Work Order ID 138472

Item ID: D206-667-107BL Accept *N900040100* Setup Start *NS1*
 Revision ID: Stop *NS2*
 Item Name: Fwd Crosstube - Mid Height 206L / L1 / L3 / L4, Blue
 Start Date: 10/28/2015 Start Qty: 1.00 *1* Cust Item ID:
 Required Date: 10/28/2015 Req'd Qty: 1.00 *1* Customer:
 Reference:

DART AEROSPACE LTD HAWKESBURY, ONTARIO, CANADA	
DRAWING NO. D206-667-147	REV. A SHEET 1 OF 4
TITLE CROSSTUBE ASS'Y (206L MID FWD)	SCALE NTS

DRAWING NO. D206-667-147	TITLE CROSSTUBE ASS'Y (206L MID FWD)	REV. A	DART AEROSPACE LTD ENGINEERING ORDER		D.E.O. NO. D206-667-147-A-1	SHEET NO. SHEET 1 OF 1	SCALE NTS
DRAWN 90	CHECKED A.S.S.	MFG. APPR. [Signature]	APPROVED [Signature]		DE APPR. [Signature]		
DATE 11.07.15	DATE 11.07.20	DATE 11.07.21	DATE 11/07/21		DATE 11.07.21

DETAIL P
BONDING STRAP INSTALLATION 2 PL

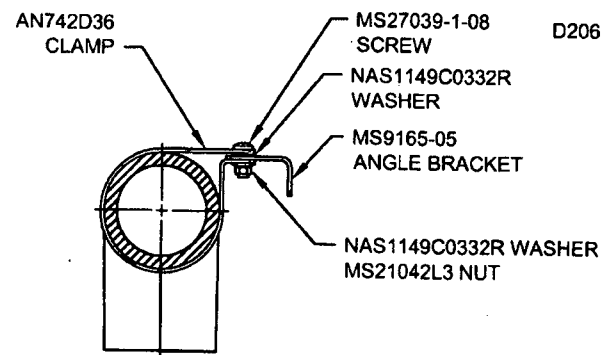
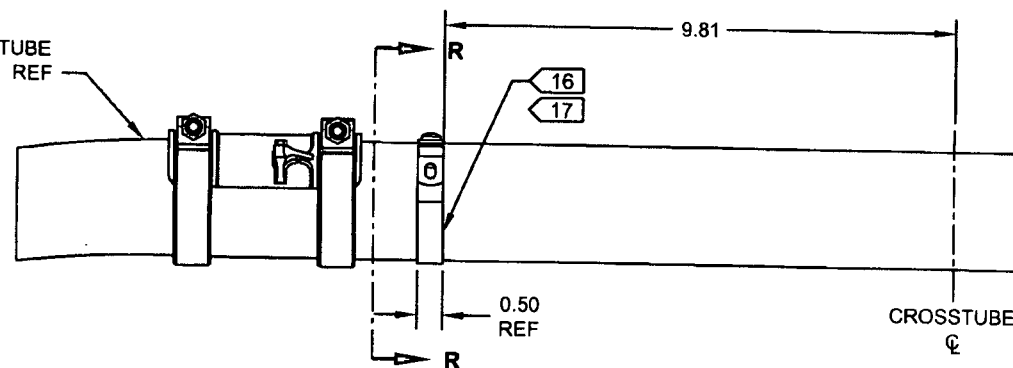
ADD ELECTRICAL GROUNDING STRAP

ITEM	QTY -147	PART NUMBER	DESCRIPTION
1	X	D206-667-147	CROSSTUBE ASSEMBLY (206L MID FWD)
10	2	AN742D36	CLAMP
11	2	MS9165-05	ANGLE BRACKET
12	2	MS21042L3	NUT (OR MS21042-3)
13	2	MS27039-1-08	SCREW
14	4	NAS1149C0332R	WASHER (OR AN960C10L)

- 16) MASK AREA UNDER CLAMP PRIOR TO PAINTING
- 17) SEAL EDGES WHERE AN742D36 CLAMP MEETS WITH THE CROSSTUBE USING SIKAFLEX-241/-291 OR MIL-S-8802 CLASS B2 OR PROSEAL 890 SEALANT
- 18) PERFORM RESISTANCE CHECK TO ENSURE MAX RESISTANCE IS 10 MILLIOHMS
